F/YR22/0354/F

134A Ramnoth Road, Wisbech, Cambridgeshire, PE13 2SW

Erect 16 x dwellings (2-storey 3-bed) with associated garages, parking and landscaping, involving demolition of existing buildings

Officer recommendation: Grant

DRAWING
PLANNING
JOB NO. 6066-PL01k PAPER SIZE A1 DATE JULY 2021

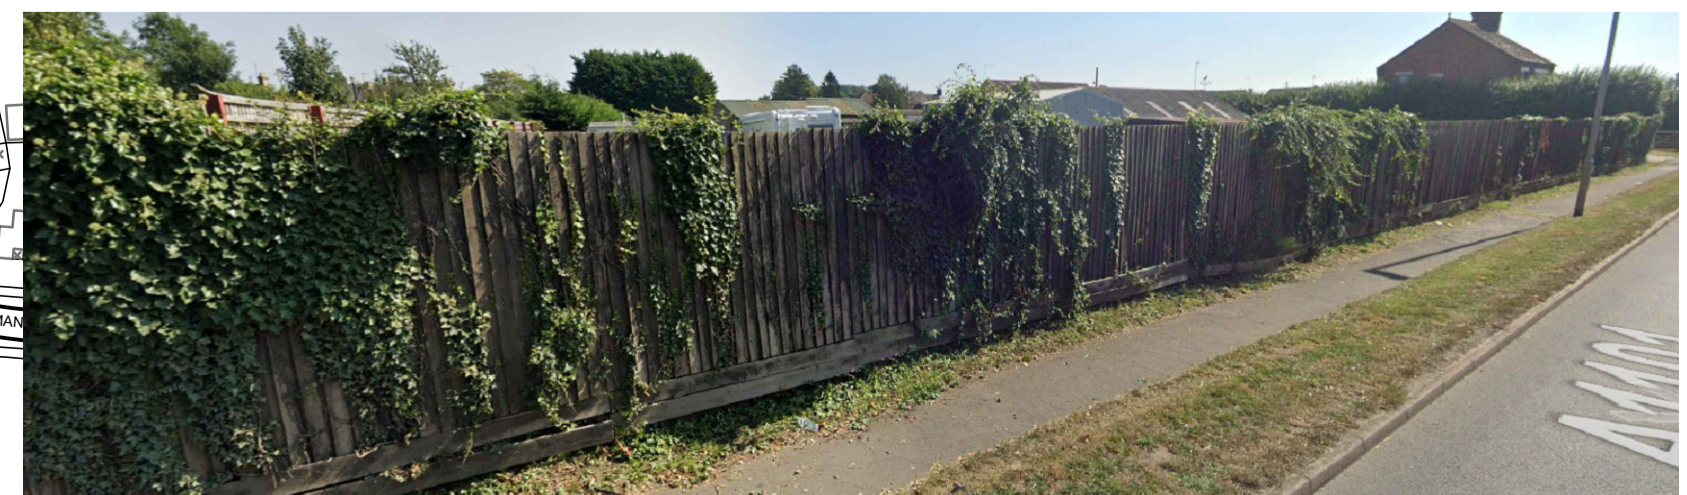
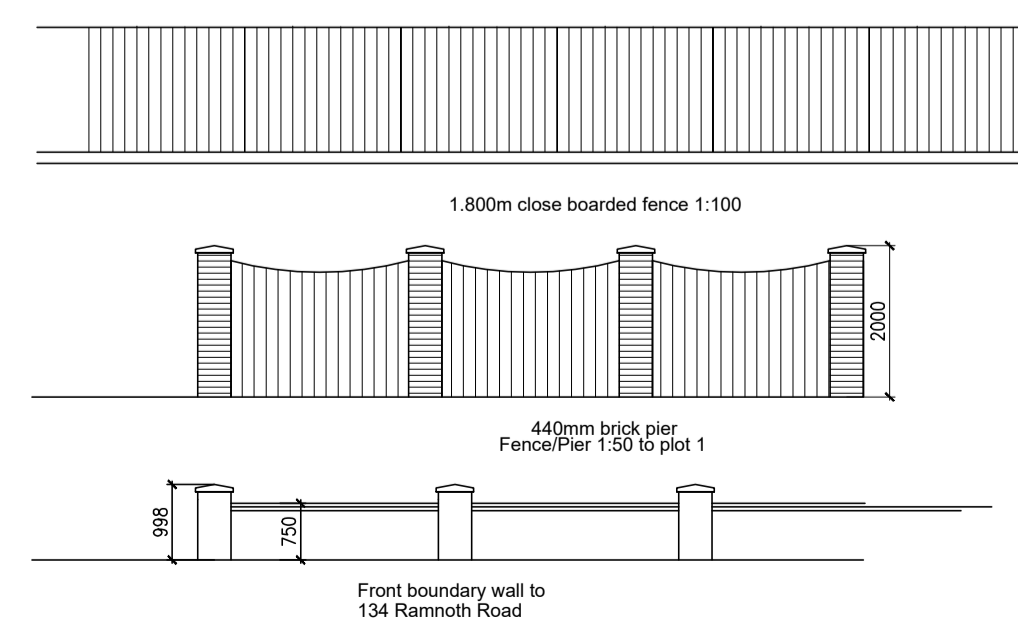
The proposed access onto Ramnoth Road is broadly acceptable but the submitted drawings lack sufficient detail. In particular, the drawings omit the tie-in with the footway immediately to the north and omit the interaction with the existing white lining (which provides a hatched buffer between the footway and nearside lane). In absence of this information, it is unclear how the access would be constructed and how it would interact with the surroundings. I recommend that the applicant be asked to provide a more detailed access drawing which includes the aforementioned detail. This may require the procurement of enhanced base mapping.

The site plan labels the internal road as 'adoptable' but the LHA will not adopt this road for the following reasons:

- Cellular storage located underneath the carriageway.*
- The road is too narrow (carriageway needs to be 6m plus x2 0.5m maintenance strips i.e., 7m total)*
- The surfacing material is incorrect as all shared surfaces need to be block paved to change the character of the road (note block paving cannot be laid flatter than 1 in 80 long fall).*

I still maintain that the applicant should amend / detail the access, because that shown on drawing 6066-PL01k is not necessarily implementable in the current form. I am however sure an access can be implemented with minor changes so should the applicant be unable to make these changes, a condition for detailed access should be appended to any permission.

- *Non-standard conditions: Prior to the commencement of development, details of an access onto Ramnoth Road shall be provided in writing and agreed by the Local Planning Authority.*
